**AMENDMENT THREE TO THE HAYES-WEST FREMONT
138 kV TRANSMISSION LINE PROJECT**

OPSB CASE NO.: 16-1595-EL-BTA

July 28, 2016

The attached Letter of Notification Application is the Third Amendment to the Hayes-West Fremont 138 kV Transmission Line Project and proposes seven adjustments to the Approved Route. The proposed adjustments are described in detail in the application.

**FIGURE 4-1A
CONSTRAINTS MAP
REVISION 1**

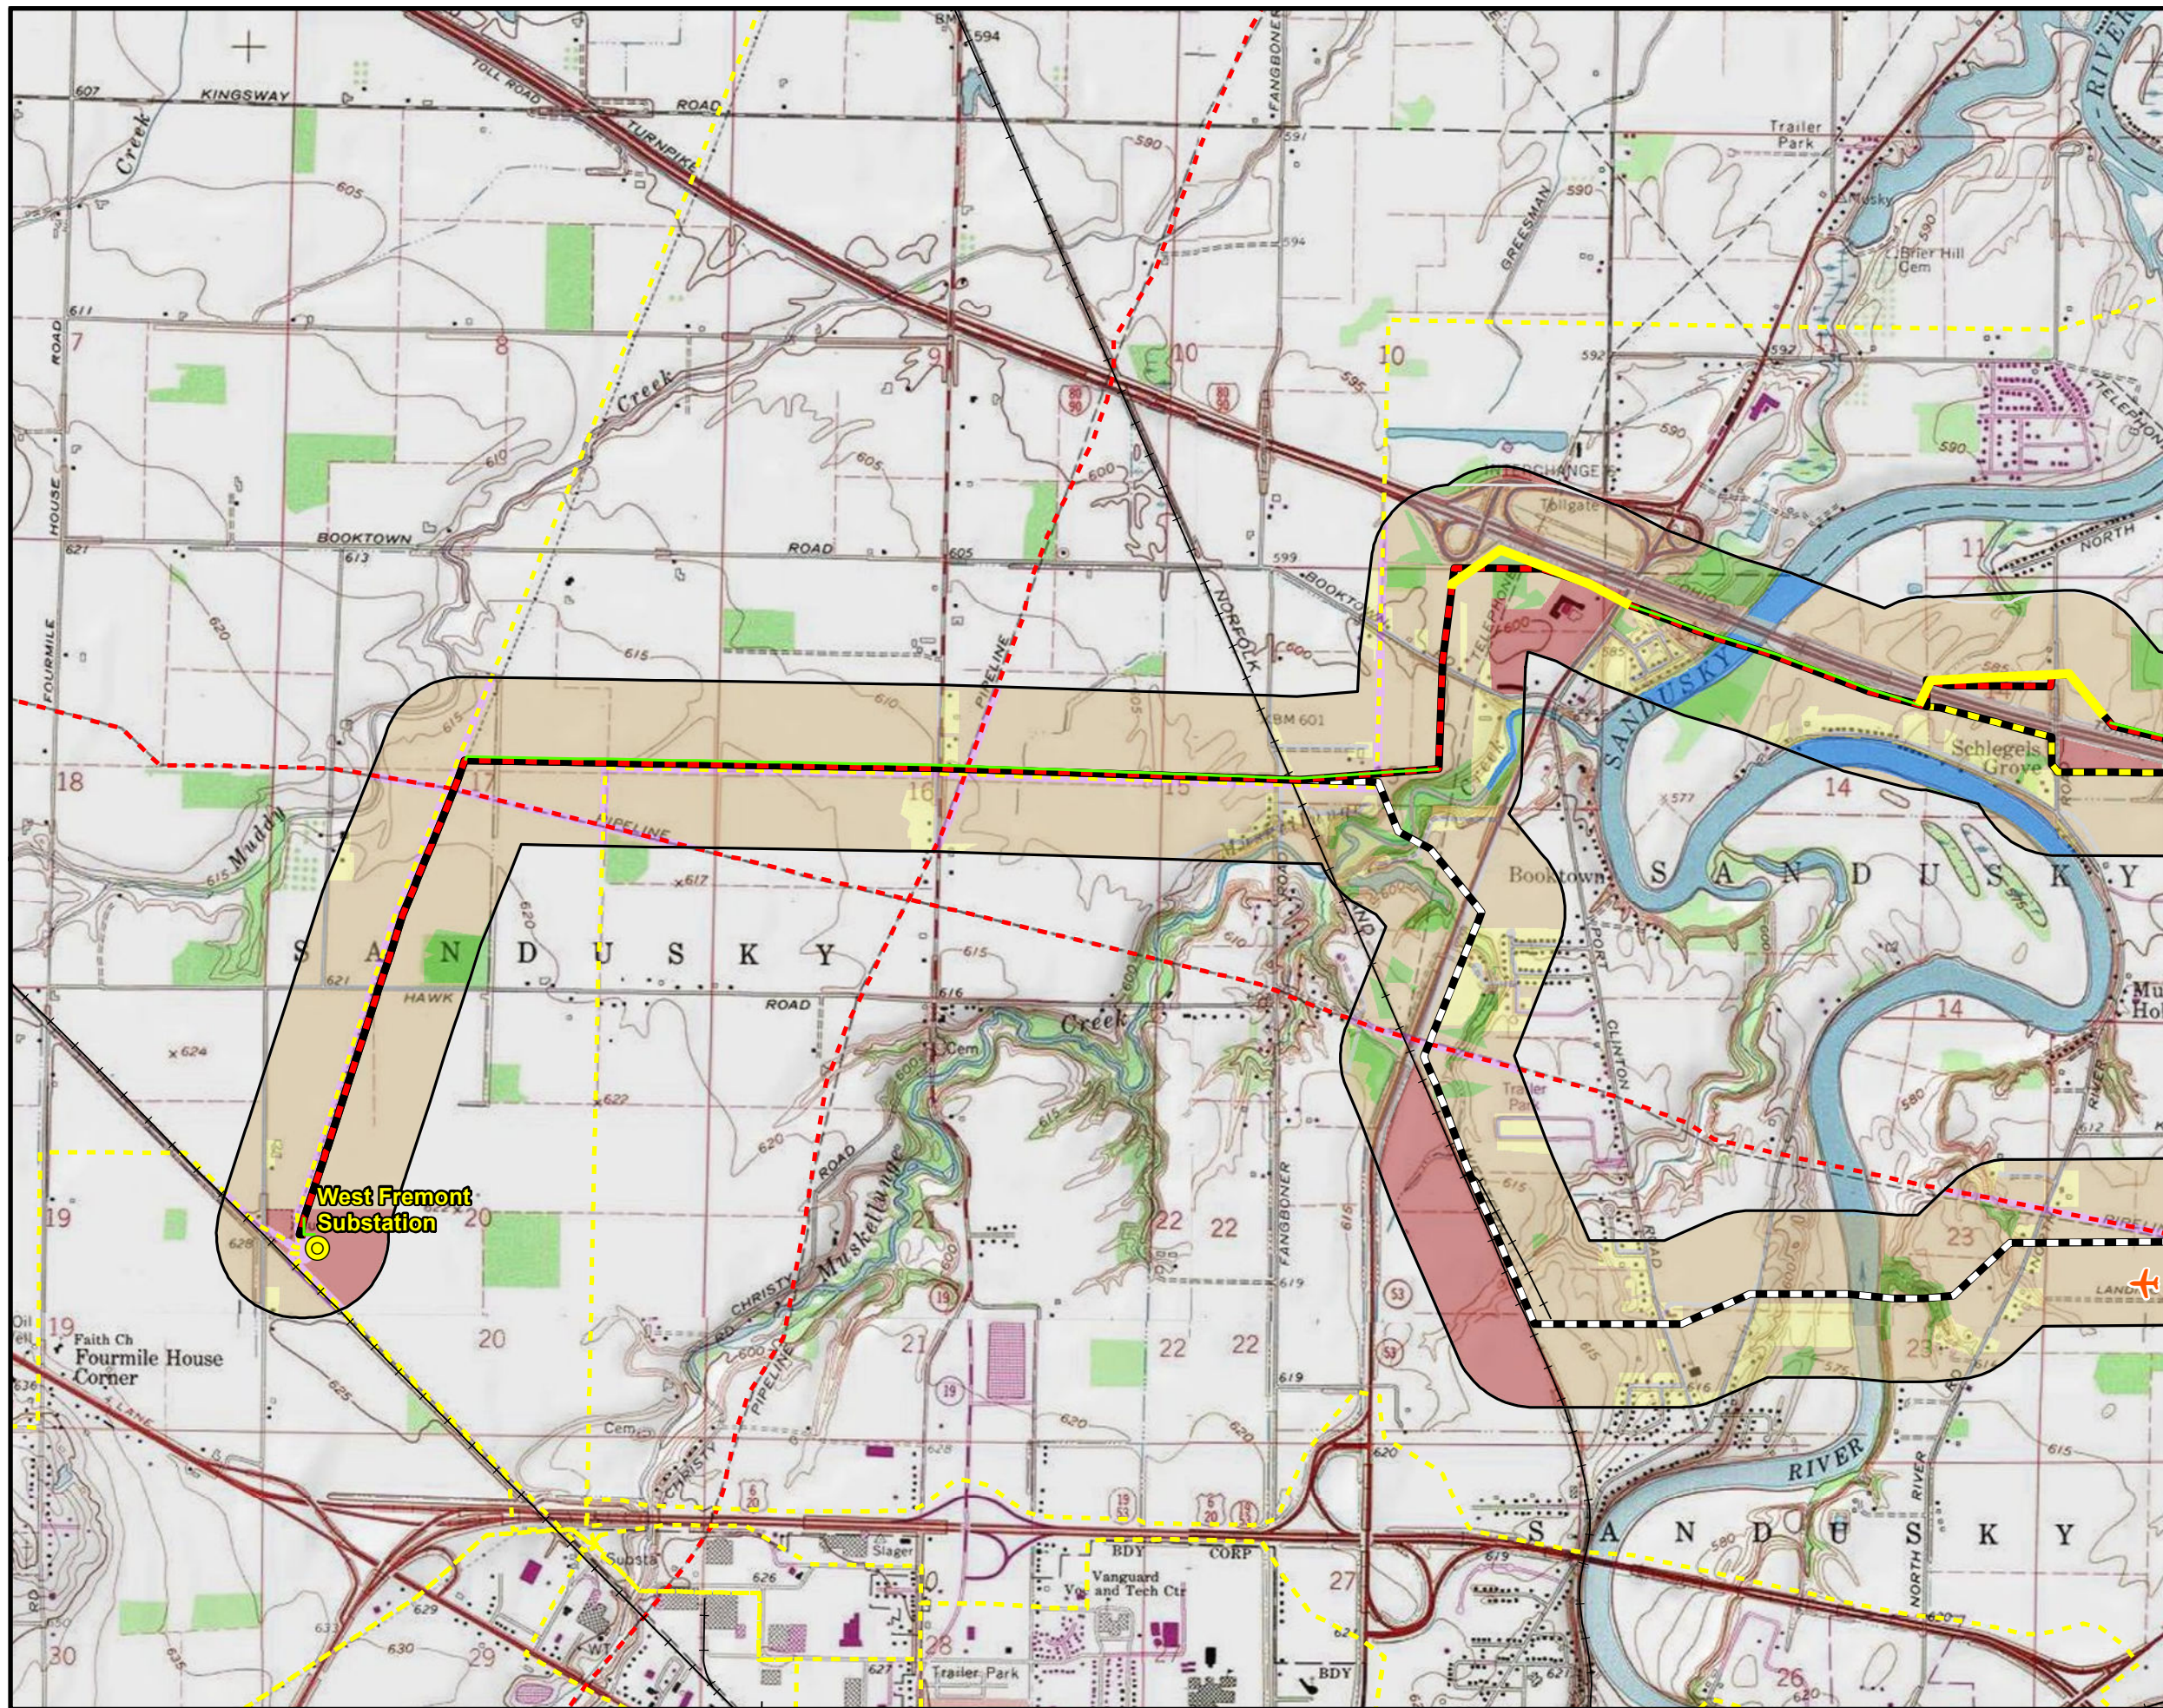
As shown in Figure 4-1A Revision 1, Land Use and Constraint Map Route OPSB Approved Route, the OPSB Approved Route crossed Shannon Road then turned south for approximately 140 feet. At this point, the OPSB Approved Route headed west for approximately 1,460 feet to a point where it headed south to cross the Ohio Turnpike. As a result of property owner negotiations, the route centerline now crosses Shannon Road and continues for approximately 1,250 feet where it slightly angles to the southwest and proceeds to an angle structure and crosses the Ohio Turnpike. The angle structure south of the turnpike has also shifted 30 feet to the east as a part of the realignment. This realignment reduces the number of angle structures in the

agricultural field and results in only one set of structures on the property owned by the Ralph L. Rathfelder Trust, as the existing distribution circuit will be relocated to the new structures and the existing distribution structures will be removed.

As shown in Figure 4-1A Revision 1, Land Use and Constraint Map Route OPSB Approved Route, approximately 500 feet west of the intersection of the OPSB Approved Route and State Route 53 the route centerline begins to shift to parallel the Ohio Turnpike/I-80 for a distance of approximately 1,545 feet. At this point, the route then turns and trends southwest for approximately 720 feet where the route then connects to the OPSB Approved Route centerline. This reroute, at the request of the property owners and reflected in easements, decreases the overall impact by trending around the perimeter of the Sunrise Hospitality property, aerially crossing the northwest corner of the property owned by Loren L. & Deborah A. Linder, and eliminates a guyed corner dead-end structure on the property owned by Ronald C. Fox, Connie M. Smith & Carol A. Waggoner.

FIGURE 4-1C
CONSTRAINTS MAP
REVISION 1

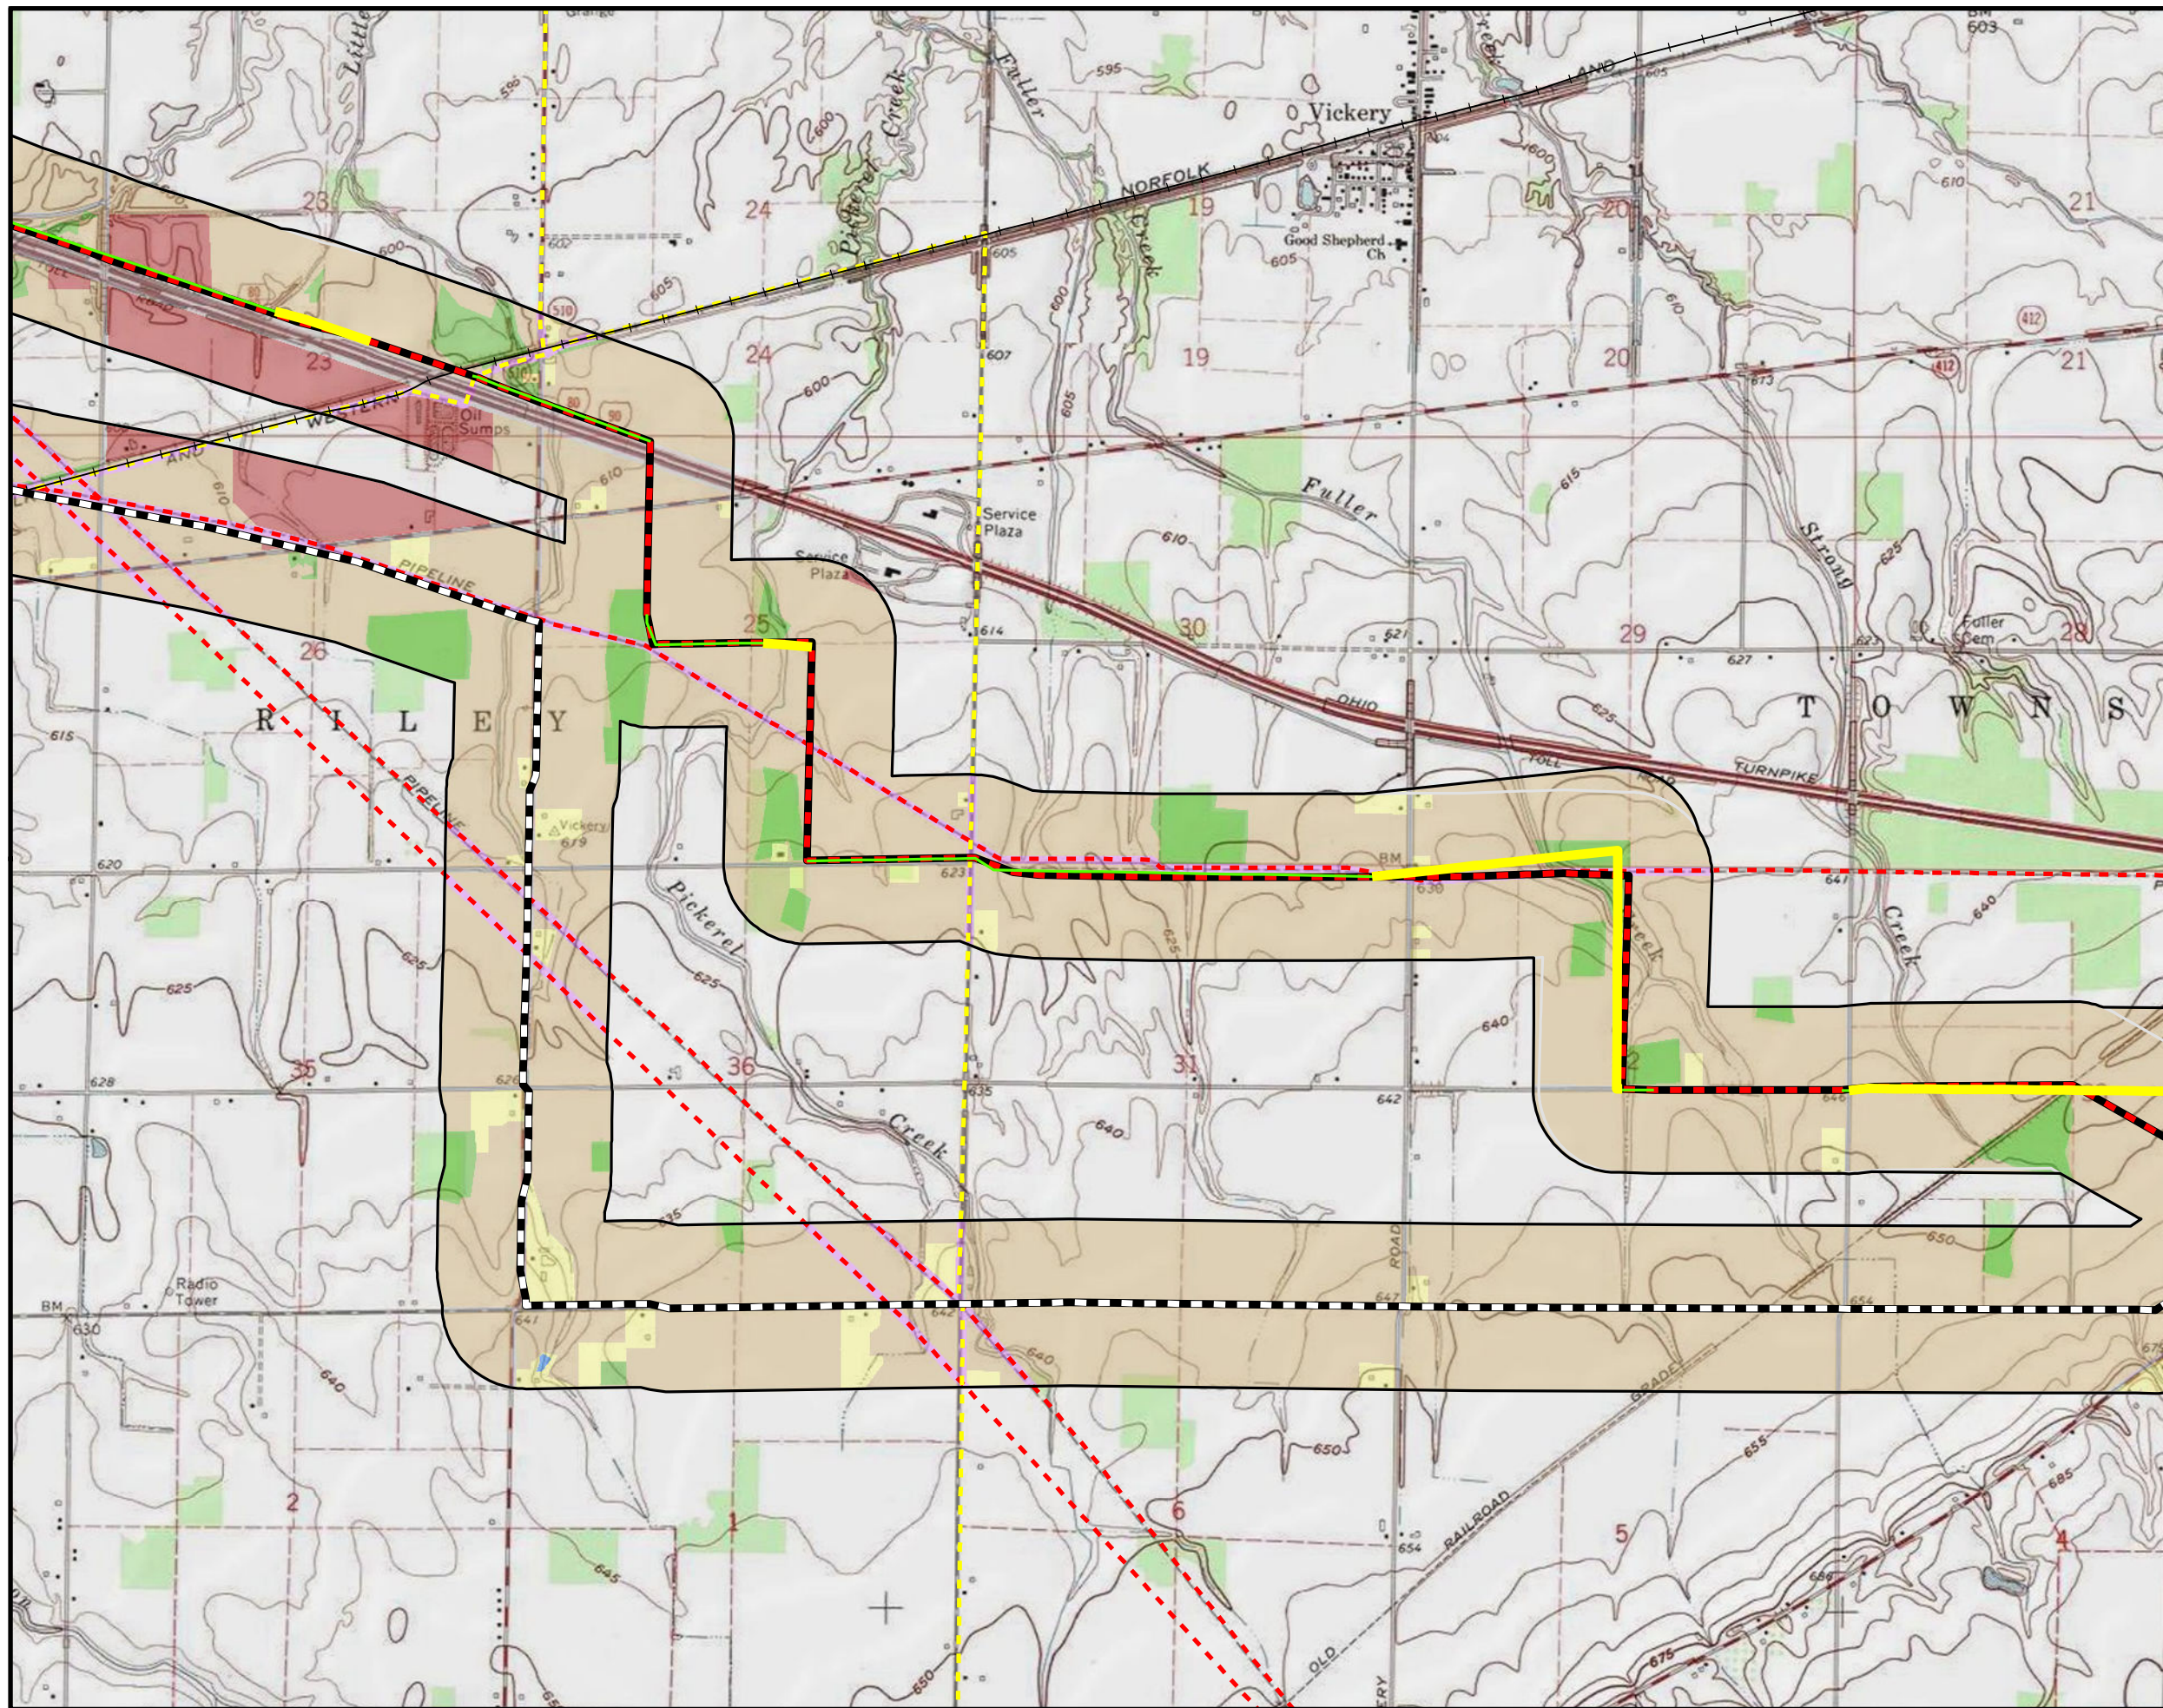
As shown in Figure 4-1C Revision 1 and Figure 4-1D Revision 1, Land Use and Constraint Maps Route OPSB Approved Route, beginning on the east side of the intersection of the OPSB Approved Route and Pickle Street and extends to the intersection of the OPSB Approved Route and Mugg Road, the route is proposed to shift south approximately 12 degrees and trend in a west-northwest direction.

Approximately 1,500 feet west-northwest of the angle structure adjacent to Pickle Street, the line turns north and follows the property line for approximately 1,750 feet to an angle structure. At this point, the line turns approximately 45 degrees to the northwest to another angle structure approximately 70 feet away. The proposed change then trends west on the northern side of the existing farm lane and continues to a point approximately 220 feet east of the intersection of the OPSB Approved Route and Mugg Road. At this point, the proposed route change trends in a slight southwest direction to connect with the OPSB Approved Route just west of the intersection of the OPSB Approved Route and Mugg Road. This proposed change is at the request of the property owner.

As shown in Figure 4-1C Revision 1, Land Use and Constraint Map Route OPSB Approved Route, the OPSB Approved Route parallels Stokes Road west of the intersection of Stokes Road and Mugg Road on the southern side of the road. Approximately 2,690 feet west of the intersection of Stokes Road and Mugg Road the OPSB Approved Route turns north. The proposed 90 degree corner dead-end structure is proposed to move approximately 63 feet to the west of the OPSB Approved corner dead-end structure. This shift in location of the 90 degree corner dead-end structure, at the request of the property owner, results in an incidental shift of the north-south alignment of this tangent section of transmission line paralleling approximately 110 feet west of the property line, north of Stokes Road.

Approximately 2,537 feet north of the intersection of the OPSB Approved Route and Stokes Road, the 90 degree corner dead-end structure is proposed to shift approximately 370 feet northwest of the OSPB Approved Route location. At this location, the OPSB Approved Route trends west approximately 2,985 feet to a two pole angle structure west of County Road 268. This proposed change is at the request of the property owner as well as the Applicant to avoid the existing gas transmission line corridor that runs east-west through this area.

As shown in Figure 4-1C Revision 1, Land Use and Constraint Map Route OPSB Approved Route, approximately 2,000 feet west of the intersection of the Fuller Road and Yorktown Road, the corner dead-end angle structure of the OPSB Approved Route shifts approximately 60 feet to the south. This adjustment moves the corner dead-end angle structure south away from a major confluence of field drainage pipes and a drainage collection area. This shift in location of the corner dead-end angle structure, is at the request of the property owner, which is reflected in the easement.

As shown in Figure 4-1C Revision 1, Land Use and Constraint Map Route OPSB Approved Route, approximately 2,700 feet west of the intersection of the Ohio Turnpike/I-80 and State Route 510, the angle structure of the OPSB Approved Route shifts approximately 557 feet west to a point adjacent to a body of water. This adjustment moves the two pole guyed angle structure out of the usable agricultural field and shifts the centerline, at the point of the new two pole guyed angle structure, approximately 100 feet north, thus decreasing the impact of the transmission line in the agricultural field. This shift in location of the two pole guyed angle structure is at the request of the property owner, which is reflected in the easement.
